Re: Response to Public Hearing Comments Notice of Intent Application DEP File #: 301-1404 200 Concord Road (Property ID: J09-0025) Sudbury, Massachusetts

[LEC File #: CBRE 23-410.04]

November 6, 2023 Letter prepared by David Fitzgerald

Re: Notice of Intent: 200 Concord Road, DEP #301-1404

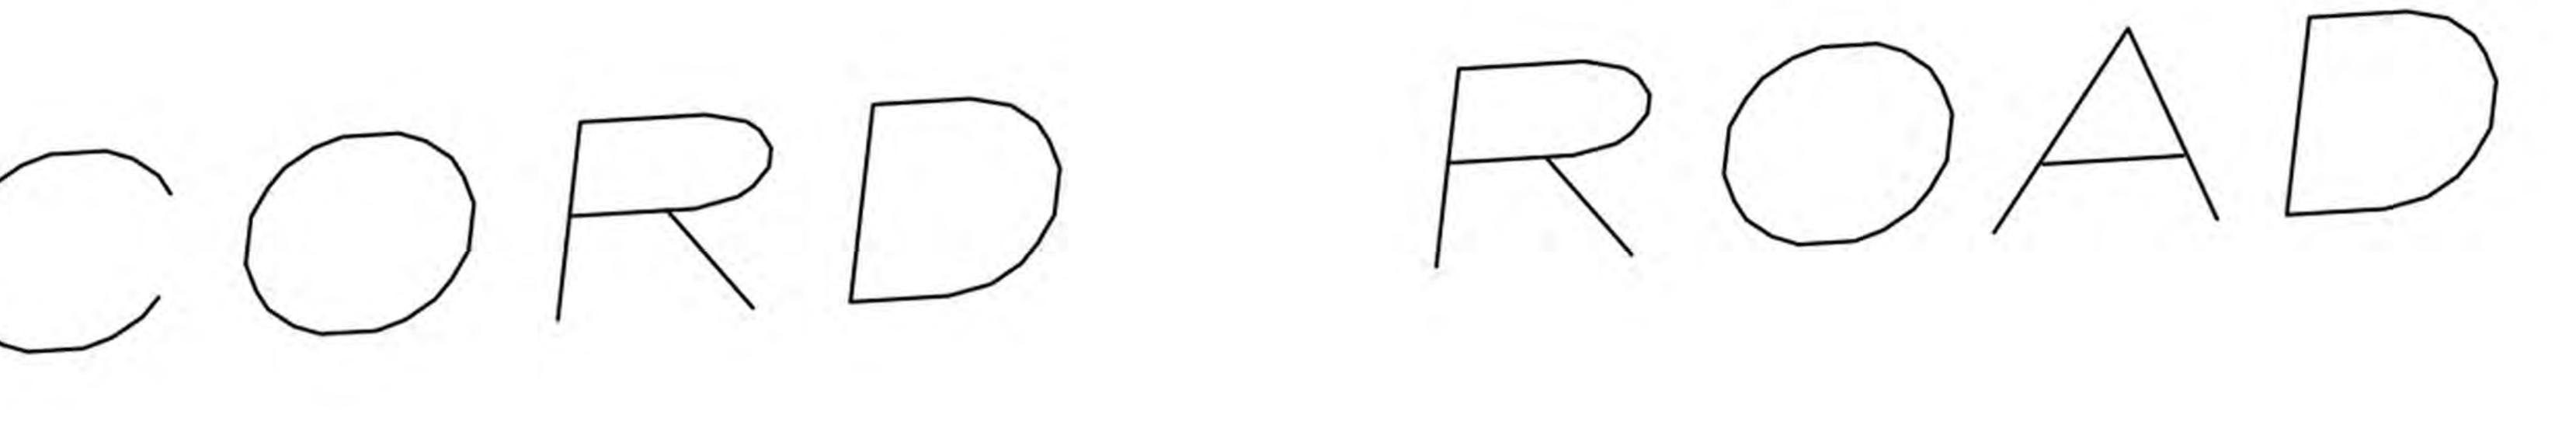
We have also reexamined the feasibility of leaving the septic system in the front yard and confirmed that is not a viable option because of the inadequate space after considering the setback requirements. Please see the attached plan which outlines the setbacks.

EXISTING SEPTIC TANK AND DISTRIBUTION BOX. PUMP, CRUSH AND BACKFILL 100 EXISTING 40' BY 15' LEACHING AREA (TO BE ABANDONED) FROM PROP -AV EROSION CONTROL/LIMIT OF WORK DRIVEWAY SX LIMIT NY/N EXISTING DENTIST POP WAY -OFFICE ____ VD V BAS. FLOOR-EL. 197.27 PROP. 4" SCH40 PVC) I=200.00 200-ARKUND A16 1.1
